**Model: CPD-200ES****No. 196****Subject: Incorrect Degauss Operation. Loose Degauss  
Coil Assembly****Date:** June 1, 1998**Symptom:  
(143)**

**DEGAUSS COIL HOLDERS AND SIDE CABLE TIES**

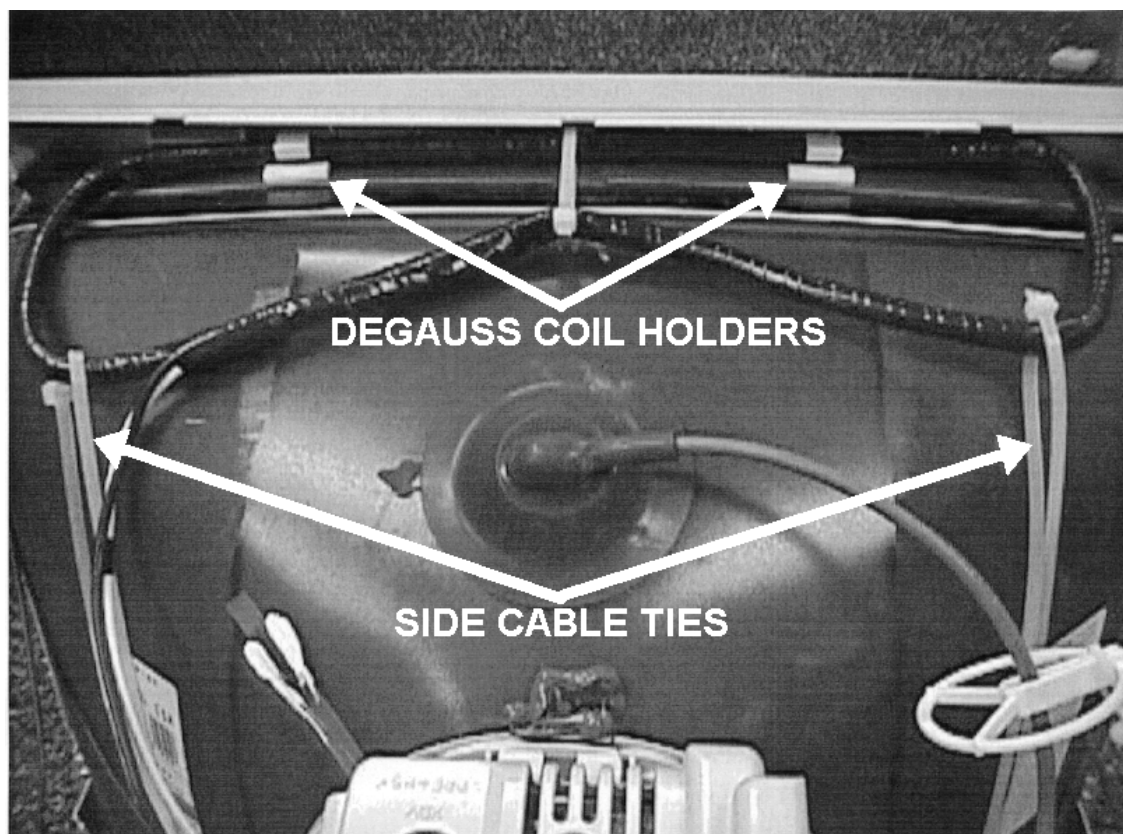
If the Degauss operation is incorrect. This may be caused by a loose Degauss Coil Assembly. Oil used to inhibit rust may prevent adhesion between the Degauss Coil Holder and the CRT mounting frame assembly. Affected units consist of part of the production with the SN range below 4070016.

1. Disassemble the unit to access the Degauss Coil assembly.
2. Locate the (4) Degauss Coil Holder locations. There are two at the top and two at the bottom areas of the CRT mounting frame assembly. Refer to the following illustration (Top Degauss Coil Holders Shown).

6. Install any required new holders to the CRT mounting frame assembly.
7. Carefully position the Degauss Coil assembly into the correct position in the holders. Adjust or replace any of the side tie wraps that are excessively tight. The side tie wraps should be snug but not tight. Refer to the following illustration.

3. Inspect each Degauss Coil area to determine if the Degauss Coil Holder has become loose or displaced from the correct position.
4. Remove and discard any loose or detached Degauss Coil Holders.

5. Clean each mounting area of the CRT mounting frame assembly where a displaced holder had been attached. Use a mild solvent. Dry these areas thoroughly.

8. Assemble the unit and verify correct Degauss Coil operation.
